Addendum for Model 1200

This manual is applicable to units bearing serial numbers above 3500 and is the same as the manual for units below that serial number except for the following:

FIGURE 5. Amplifier Simplified Schematic

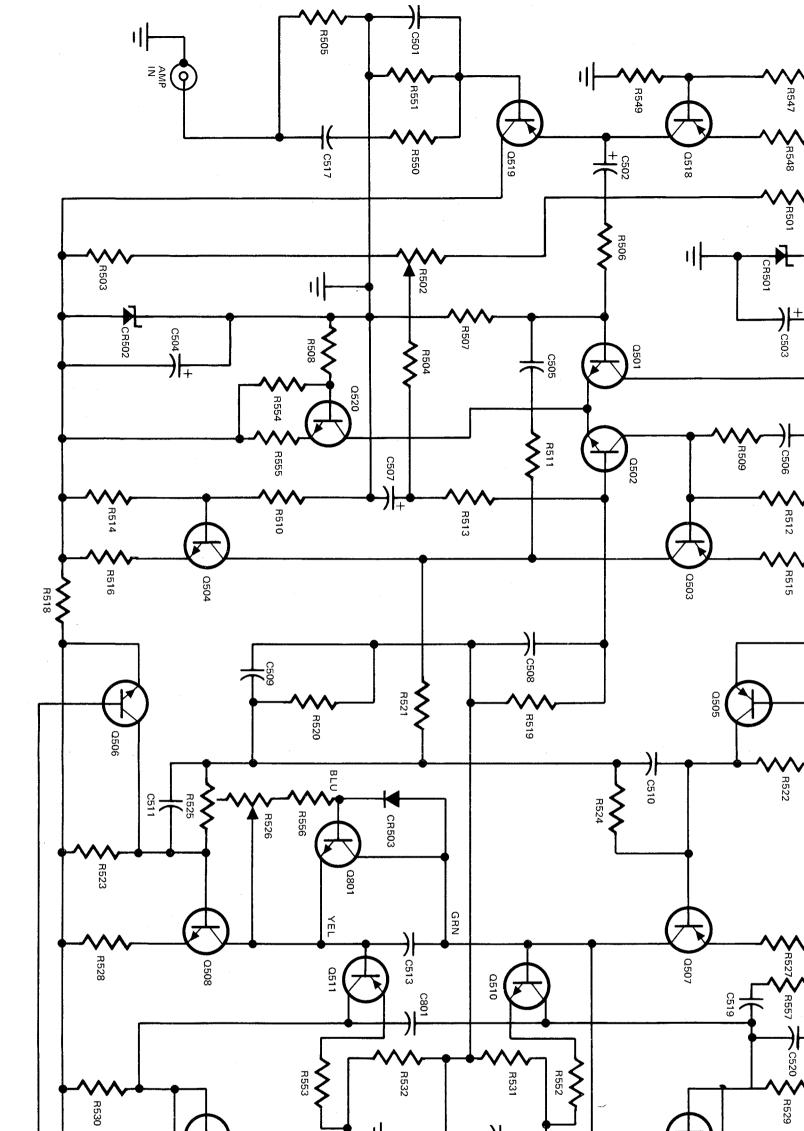
Pages 6 – Replace Figure 5 (Amplifier Simplified and 7 Schematic) with Figure 5 contained herein.

FIGURE 20. Model 1200 Schematic, A

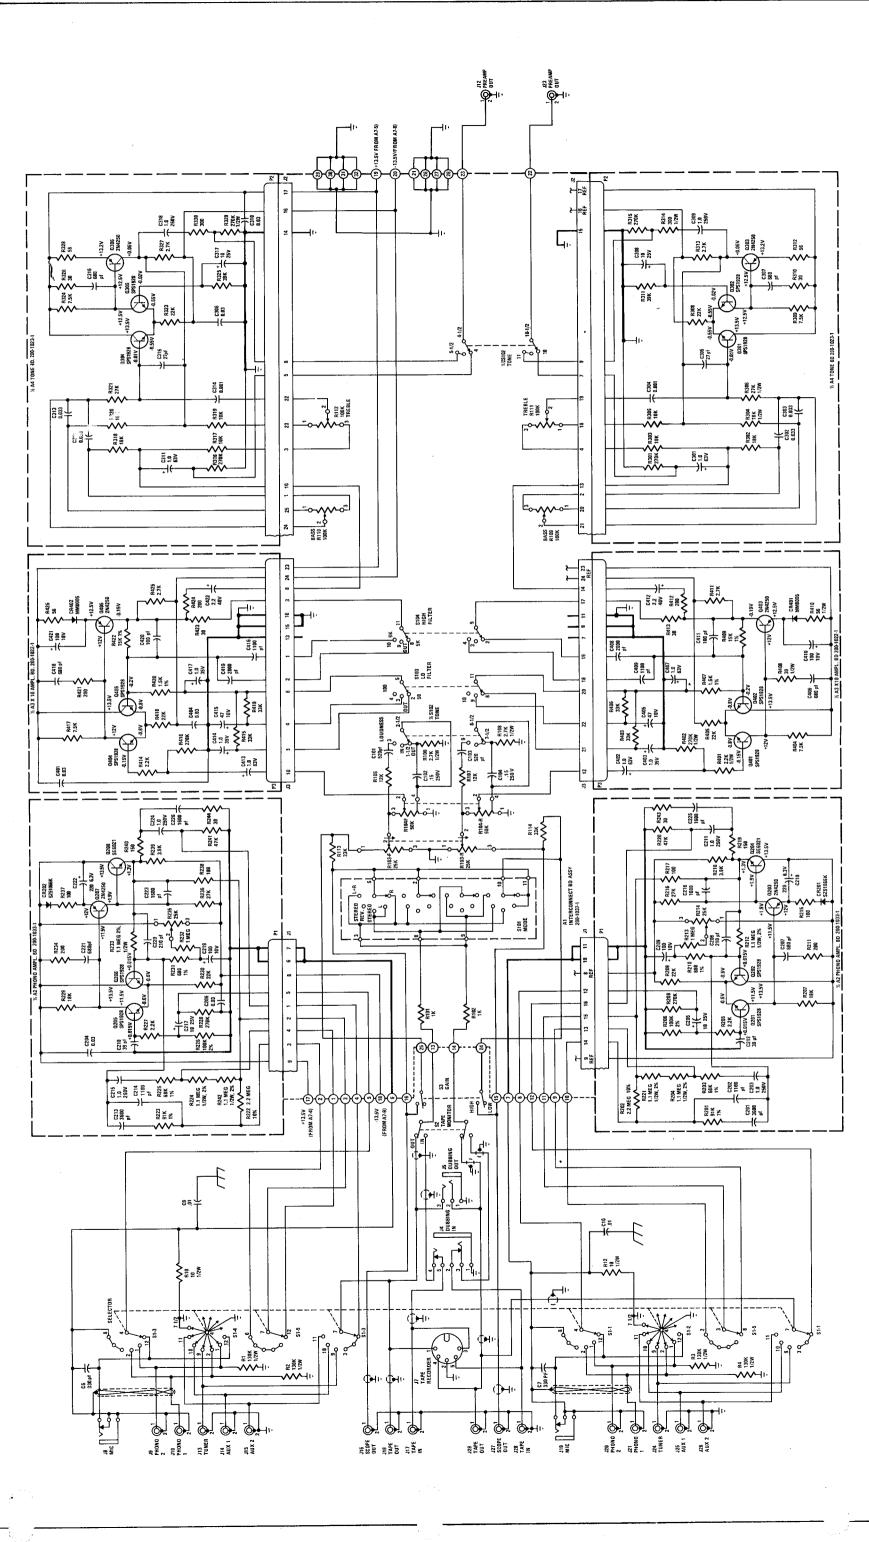
- Pages 34 Replace Figure 20. (Model 1200 and 35 Schematic, A) with Figure 20 contained herein.

FIGURE 21. Model 1200 Schematic, B A

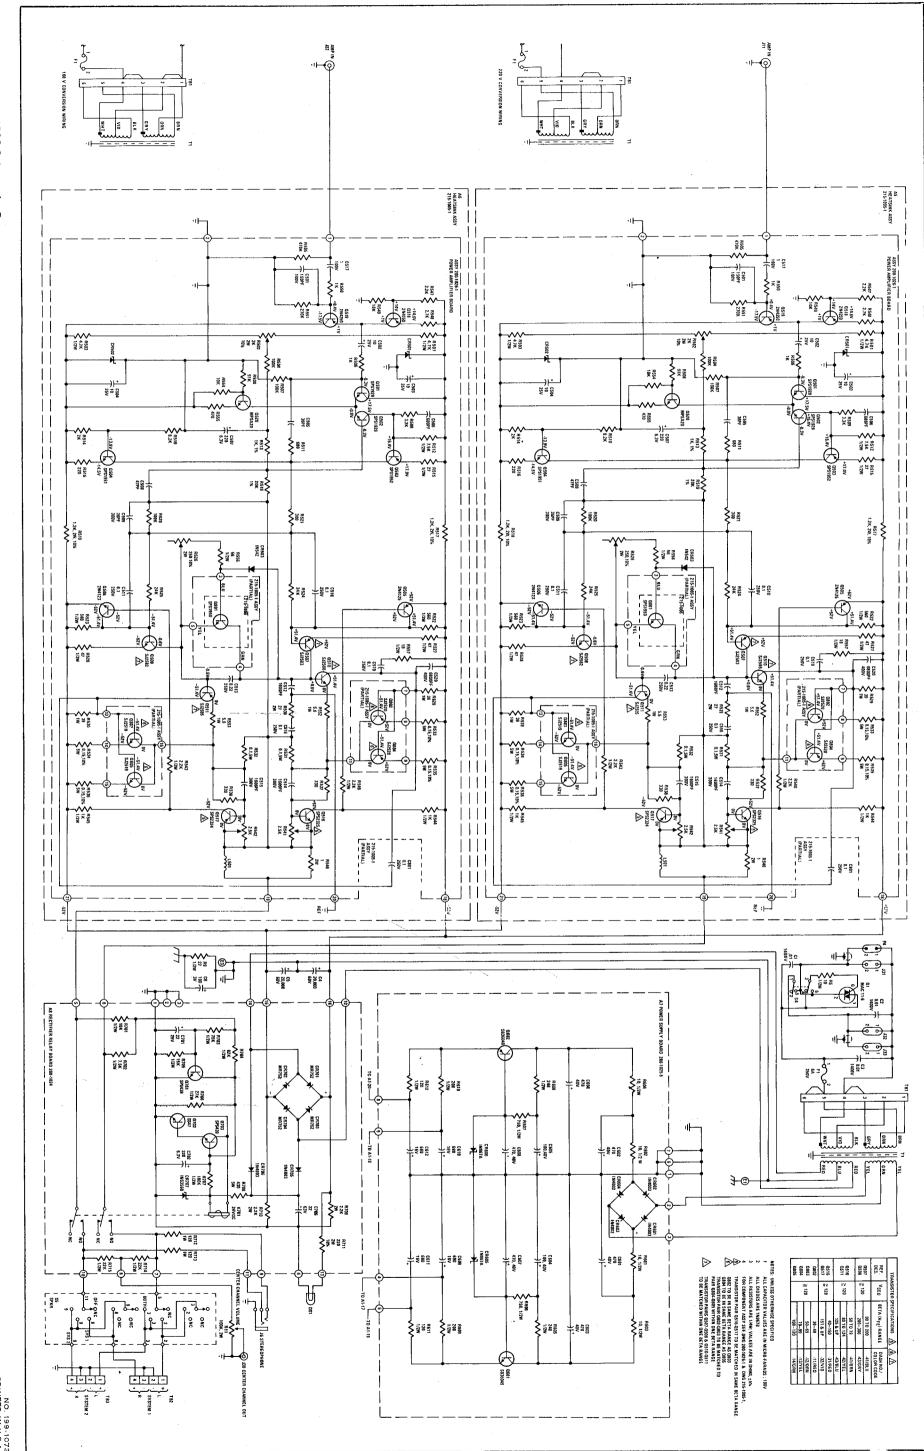
Pages 36 – Replace Figure 21. (Model 1200 and 37 Schematic, B) with figure 21. contained herein.

MODEL 1200 240V CONVERSION

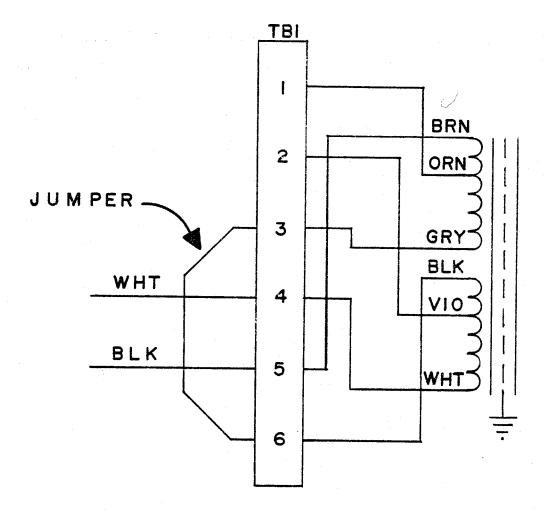
To convert the Model 1200 to 240 volt operation, perform the following steps:

- 1) Remove top cover.
- 2) Orient the Model 1200 so that the rear panel is facing towards the viewer.
- Locate TBl, the strip located on the power transformer half shell facing the rear panel, which terminates the power transformer primary wires.
- 4) Unsolder the black and the white power lead-in wires and all jumpers from TBL.
- 5) Solder a jumper on TBL connecting the grey and black transformer wires.
- Solder the black and the white power lead-in wires to the brown and the white transformer wires, respectively, on TB1.
- 7) Replace the top cover.
- 8) Replace the 6 amp. 250V fuse in the unit with a 4 amp. 250V fuse, part number 451-1003.
- 9) Verify that unit operates properly.

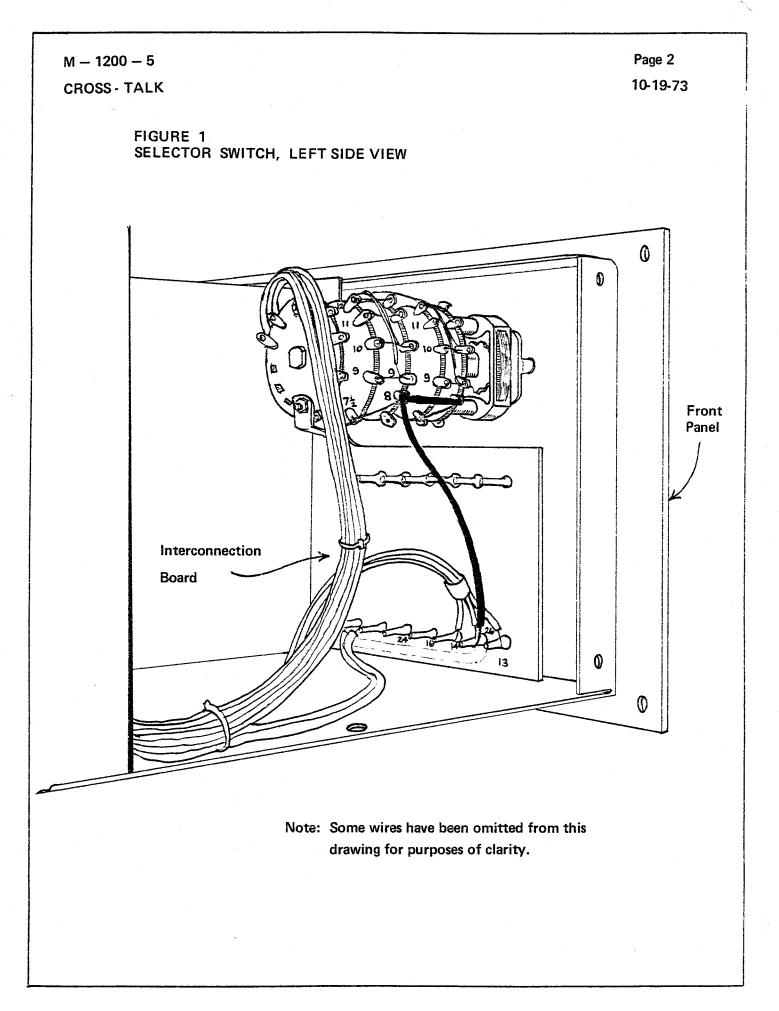
The cross-talk may exist when the unit is used in the phono mode, while source is applied to the high inputs (Tuner, Aux 1, Aux 2).

The following modification is recommended and should only be performed if the specific symptom fits the above case.

Perform the modification of the selector-switch in the numbered sequence listed below:

- Install and solder jumper between pin 8 of deck 1 and pin 8 of deck 3.
- 2) Install ground connection by soldering a piece of flexible wire from pin 8 of deck 3 to terminal 26 on the interconnecting board as shown in figure #1.
